Newmar Corporation

RSB 585
September 30, 2022

NHTSA #22V 584
TC #2022-550

RECALL SERVICE BULLETIN

Figure 1: Model Number and Date Code Examples

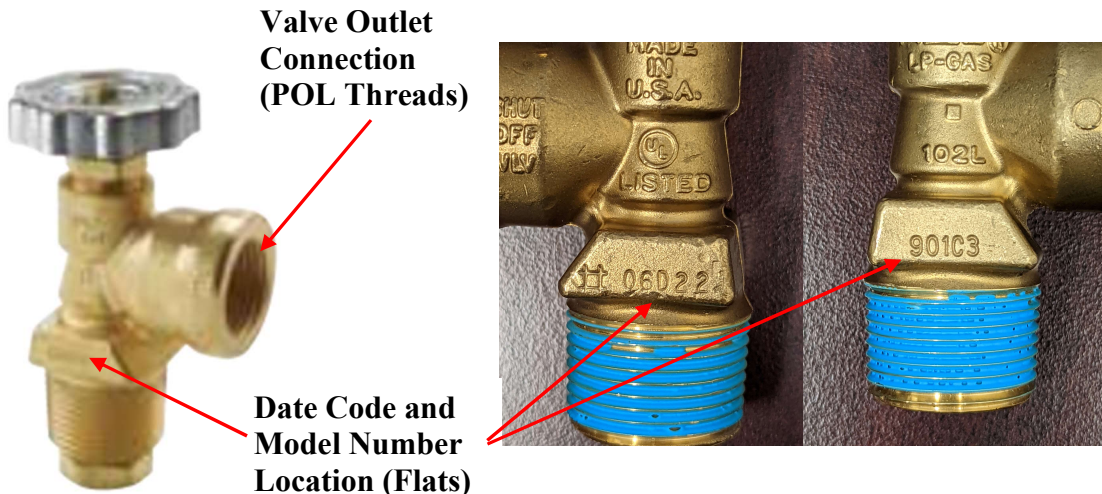
Which Valves May Be Affected? The affected valves have manufacturing date codes between 02X21 and 02X22. The ‘X’ represents any letter between A through E, which denotes the week of the month the valve was assembled. The date code is marked on a wrench flat. Below is a key to reading the date codes marked on the wrench flat of the valve and their locations. (See Figure 1.)

What Should Be Done? Contact a professional to locate the service valve on the container to inspect the model number and date code to determine whether the valve is in scope. If the date

Figure 2: Go/No Go Gauge POL Nut – Groove Cut Through Roll Stamp Information

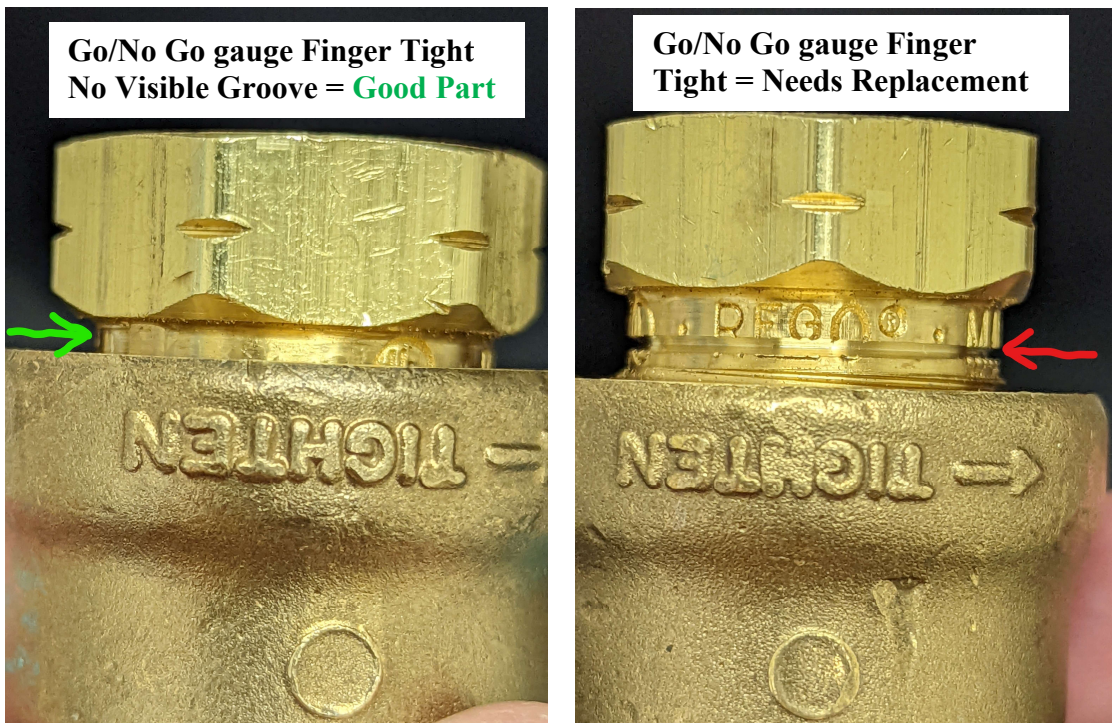
- a. Use the supplied go/no-go gauge POL nut to determine if the threads are the proper depth. (See Figure 2.) If the threads are not the proper depth, securely close the valve, remove the container from service, and replace the valve. Do not use the container without first replacing the valve.

- a. Remove the POL connector from the outlet of the service valve and use the supplied go/no-go gauge POL nut to determine if the service valve threads are the proper depth. (See Figure 2).

- i. If the threads are the proper depth, no further action is required.
 - ii. If the threads are not the proper depth, securely close the valve, remove the container from service, and contact your OEM, distributor, or dealer for further guidance.
